ORDINANCE 12-01

TO AMEND THE OUTLINE PLAN AND DISTRICT ORDINANCE FOR PARCEL I OF THE WOOLERY PLANNED UNIT DEVELOPMENT (PUD) – Re: 1480 W. Tapp Road (Tommy and Lesli Berry, Petitioners)

BLOOMINGTON PLAN COMMISSION
FIRST HEARING STAFF REPORT
LOCATION: 1800 W. Tapp Road

CASE #: PUD-29-11
DATE: November 7, 2011

PUD-29-11
Grading Plan

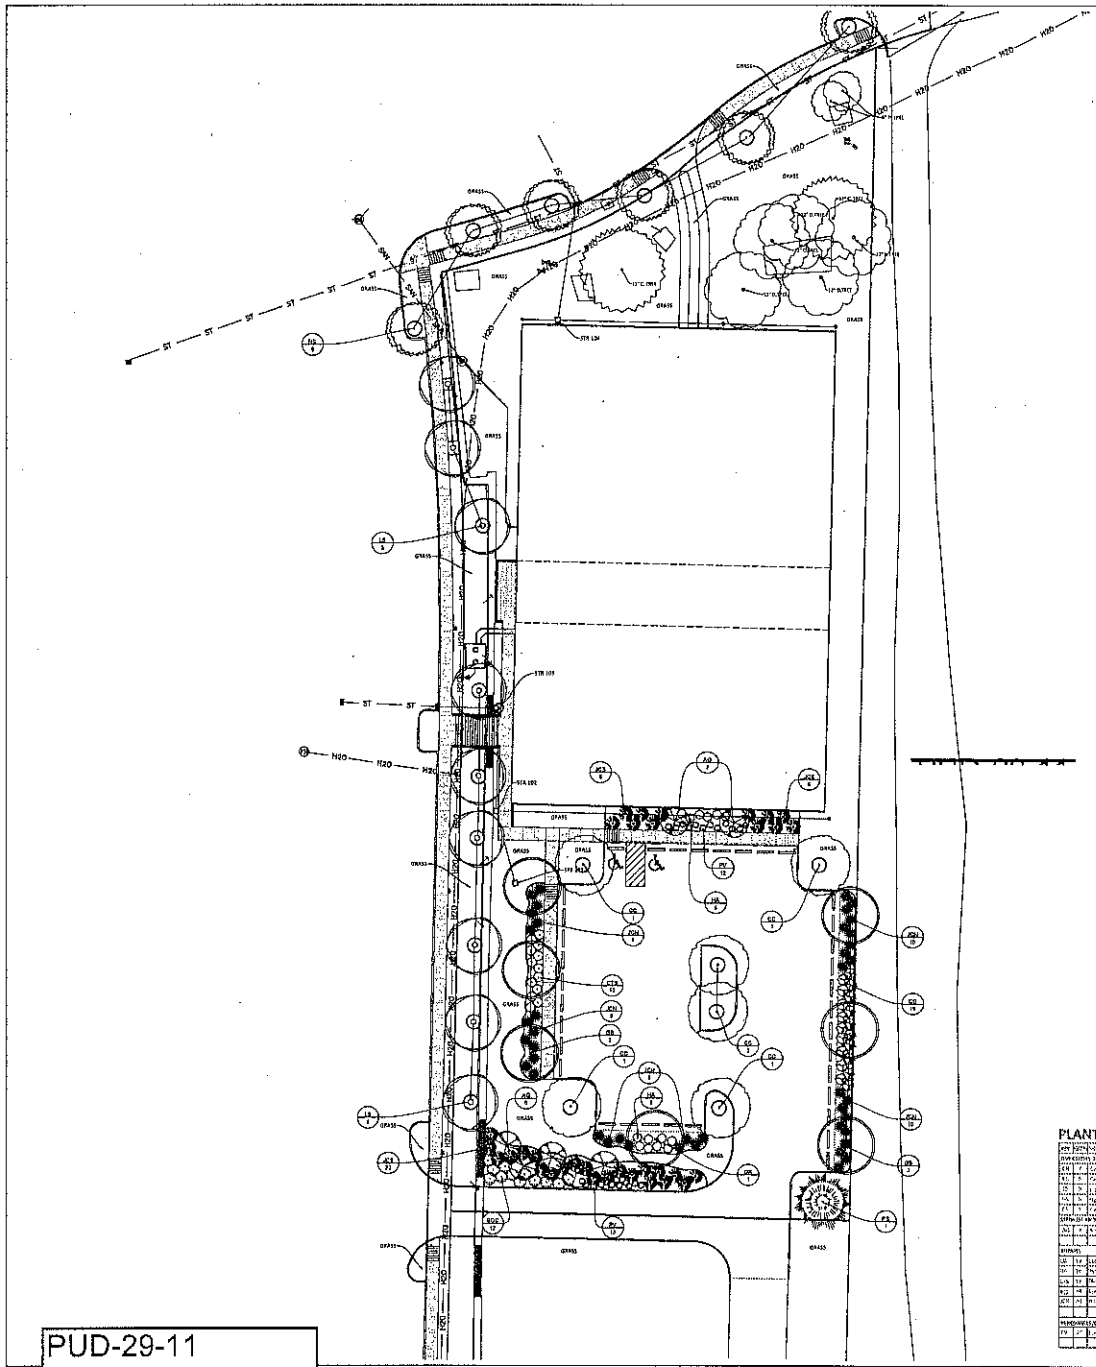
Stormwater: The petitioners have submitted preliminary stormwater calculations to City Utilities for review. While City Utilities has not yet completed their review, the primary issue is whether the large pond to the west was approved to handle the required stormwater detention and water quality requirements for this site. If so, the petitioners may not be required to provide on-site detention. If not, the petitioners would need to meet stormwater detention and water quality requirements independent of the pond. The petitioners' consultant has indicated to Staff that this could be handled through underground detention.

Regardless of whether City Utilities permits the ponds to count toward requirements for water quality, the UDO requires any parking lot of 16 spaces or more to either utilize pervious pavers or natural stormwater filtration (such as bio-swales or rain gardens) to filter parking lot run-off. The petitioners would like the existing Woolery Stone Mill ponds to count toward this requirement also. The Environmental Commission believes this requirement should be met on the site. In general, staff agrees with the Environmental Commission recommendation. Staff is seeking feedback from the Plan Commission on this issue.

2.) LOW IMPACT DEVELOPMENT:
The EC recommends that the areas north and west of the building, which are planned with traditional landscaping, be re-designed as biofiltration swales. The islands in the parking lot should also be redesigned to be biofiltration swales, thus stormwater from the building and parking lots can be slowed down and filtered before it enters the floodplain as described in UDO 20.05.070 (m) Parking Standards; Surface Material.

2.) The Petitioner should construct bioswales for water quality and quantity north and west of the building and in the parking lot islands.

PUD-29-11
Building Elevations

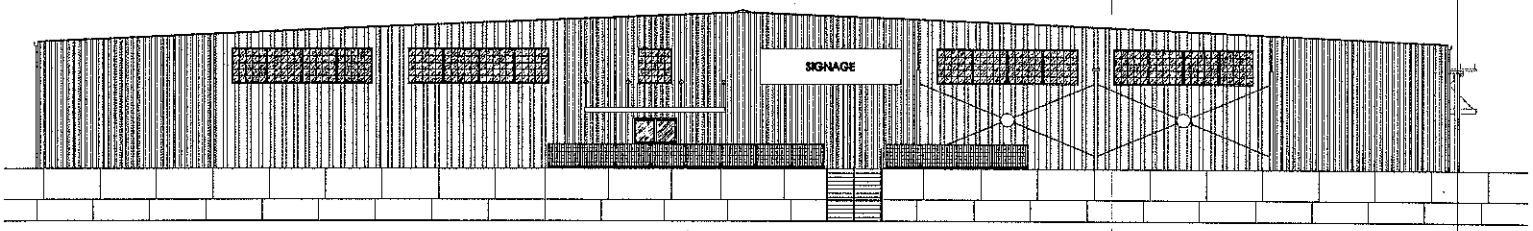
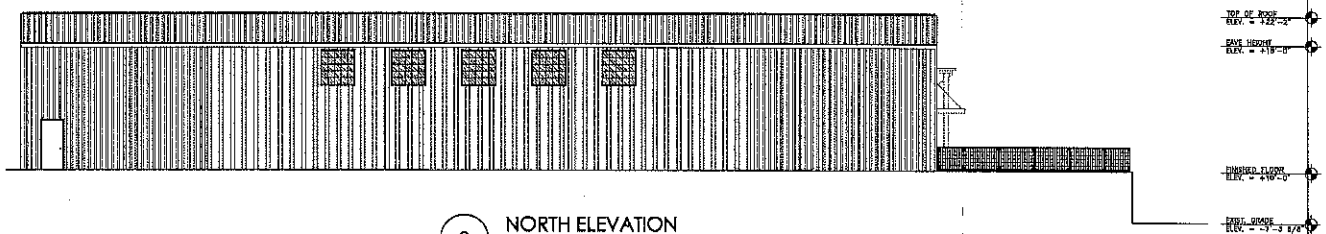
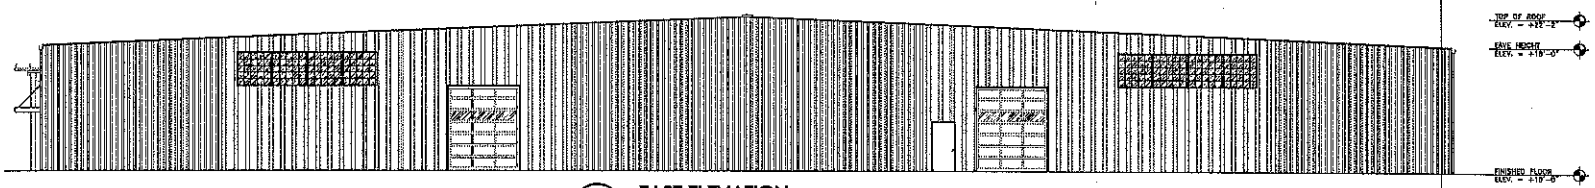
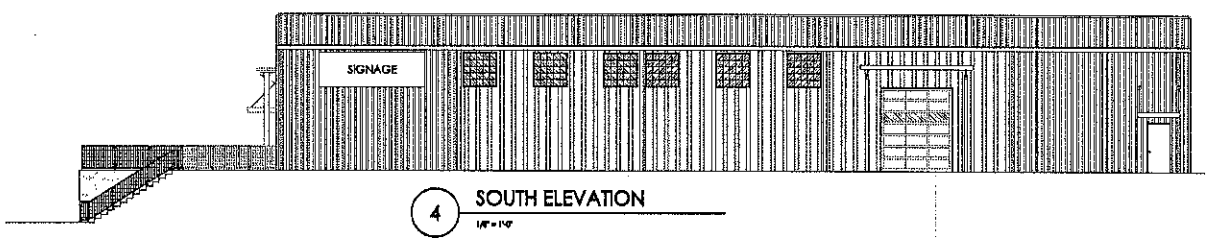
Architecture: The petitioners propose to utilize an industrial aesthetic for the design of the building. The building would have a low-pitched metal roof and would utilize vertical metal siding and windows placed high on the wall. The petitioners' architect designed the building to compliment the former industrial Woolery Stone Mill and the yet to be constructed along Keg Rd. These buildings were 2-3 stories tall and included vertical metal siding, large square windows and little ornamentation.

In addition, the nature of the proposed use may not lend itself well to the architectural requirements of the UDO, especially the requirements for changes in modulation and large windows. Other similar style buildings include the Twin Lakes Recreation Center and the YMCA.

Approval of this PUD amendment, with this architecture, would have to include changes to the Architecture Standards in the UDO. The proposed building violates the following UDO architectural requirements:

1. Materials: Metal siding not permitted
2. Blank wall: Areas of blank wall greater than 40 feet not permitted
3. Patterns: Changes in color and texture required and not provided
4. Roofing: Parapet or roof eaves required and not provided
5. Entrances: Incomplete pedestrian entry detailing

Additionally, a metal pole-barn building is generally considered neither attractive or energy efficient. The EC would encourage the developer to re-design the building to fit better with the esthetics of the surrounding area rather than distract from the unique picturesque look of the rest of the PUD.

With this PUD amendment, the Plan Commission also approved changes to the Architecture Standards in the UDO. The proposed building can be built as depicted and would not have to meet UDO standards for materials, blank wall control, roofing style and entrance detailing.
